**Lujer Realty
(Sub.)**

TOWN OF NEW WINDSOR
PLANNING BOARD
REVIEW COMMENTS

PROJECT NAME: Lujer Realty Subdivision
PROJECT LOCATION: Bull Road near Carpenter Road
NW #: 86-57
10 December 1986

SUBDIVISION
FOR

FIGURE 11
ABSORPTION TRENCH DETAIL

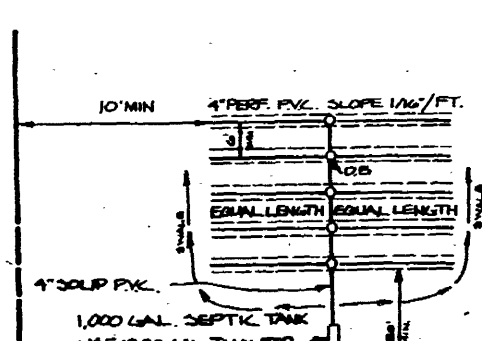
2). The Septic Design for Lot No. 3, as shown on the design drawing, indicates an absorption trench length of 230 lineal feet. Please confirm that this number is correct for the indicated percolation conditions.

LOT NO. 1 - EVAPOTRANSPIRATION - ABSORPTION SYSTEM - BED AREA = 2,250 FT² (3 BDRM)
LOT NO. 2 - " " " " " "
LOT NO. 3 - ABSORPTION TRENCH REQUIRED = 321 L.F. (3 BEDROOM)
" " " " = 429 L.F. (4 BEDROOM)

SHEET 1 OF 1	SUBDIVISION FOR		
REVISIONS:	LUJER REALTY		
NOV. 14, 1986 Δ 12-12-86	SCALE: 1" = 50'	JOB NO. 86-61	DRAWN BY: J. F.
	DATE: 7-17-86		REV:
TOWN OF NEW WINDSOR			
ORANGE COUNTY, NEW YORK			
ZIMMERMAN ENGINEERING & SURVEYING, PC RT. 17M HARRIMAN, N.Y.

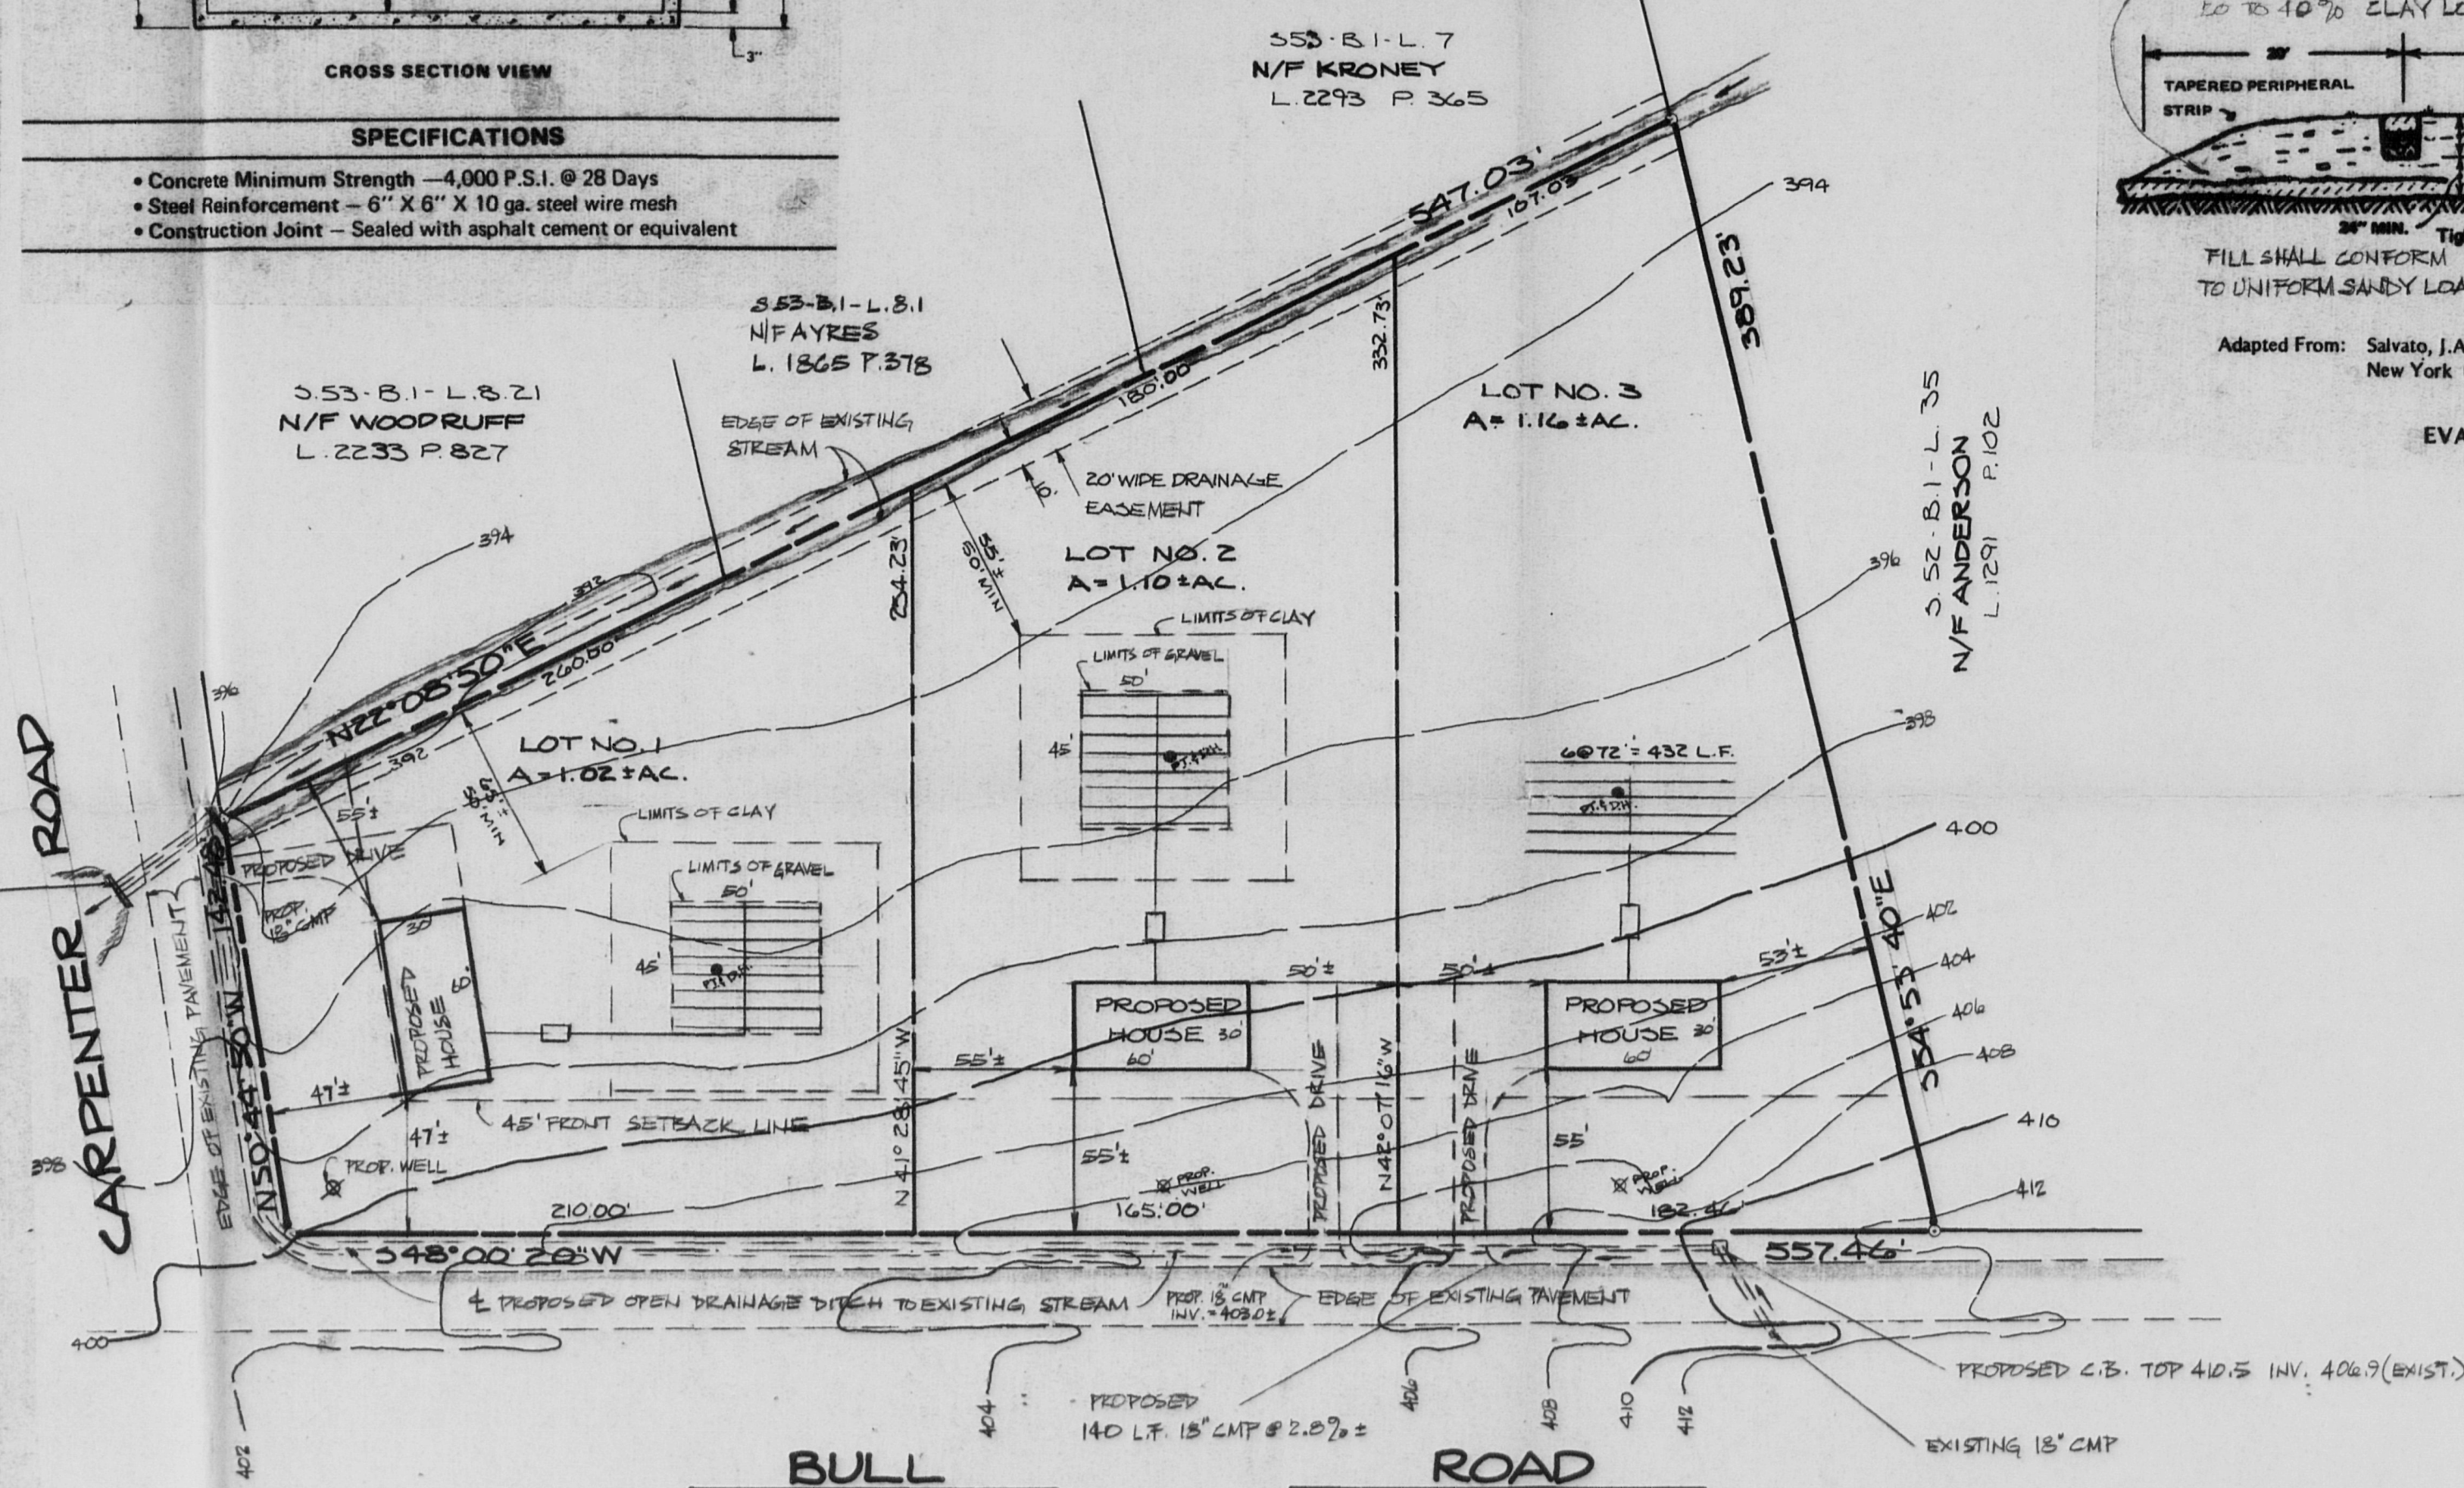
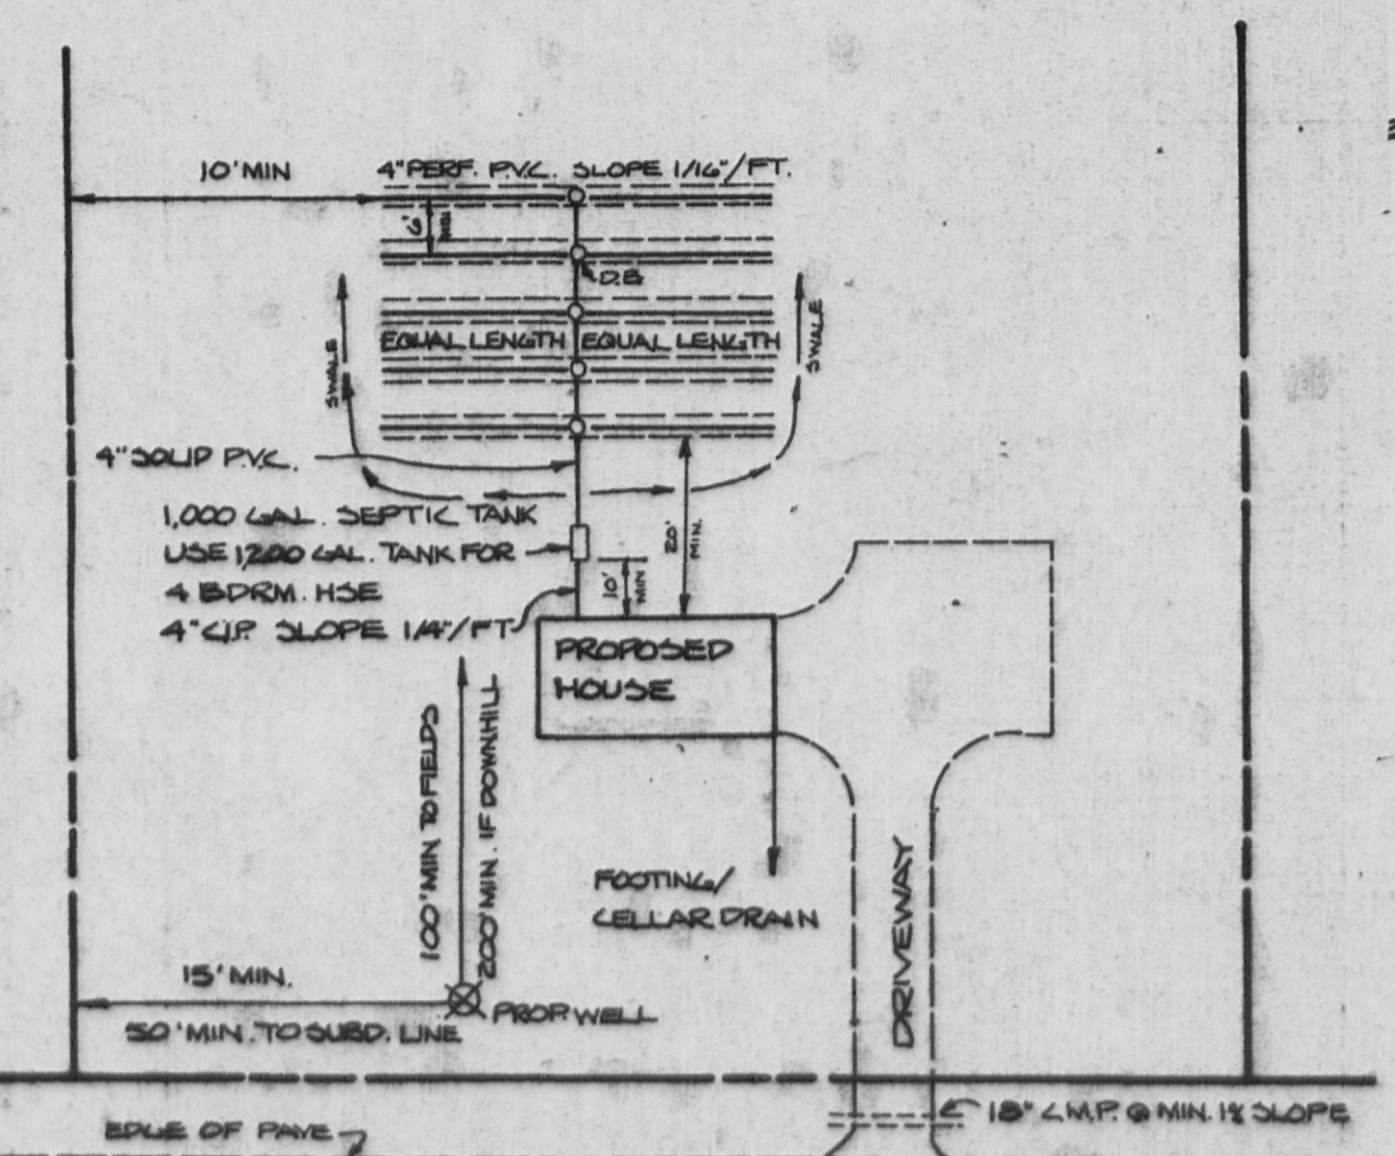
2). The proposed well for Lot #1 is not shown.

3). Field review of the project site indicates a significant drainage path running along the rear section of the proposed lots, with a twin culvert crossing existing across Carpenter Road. Future submittals should include the actual location of this culvert and the actual drainage path such that the easement required can be evaluated for necessary width.

4). Future submittals should include Percolation Test Data and Deep Test Data indicating no problem with groundwater at the proposed Sanitary System locations. The type of Sanitary System proposed with design and details should be included.

5). Plans shall contain a note certifying to the accuracy of Survey and Plat.
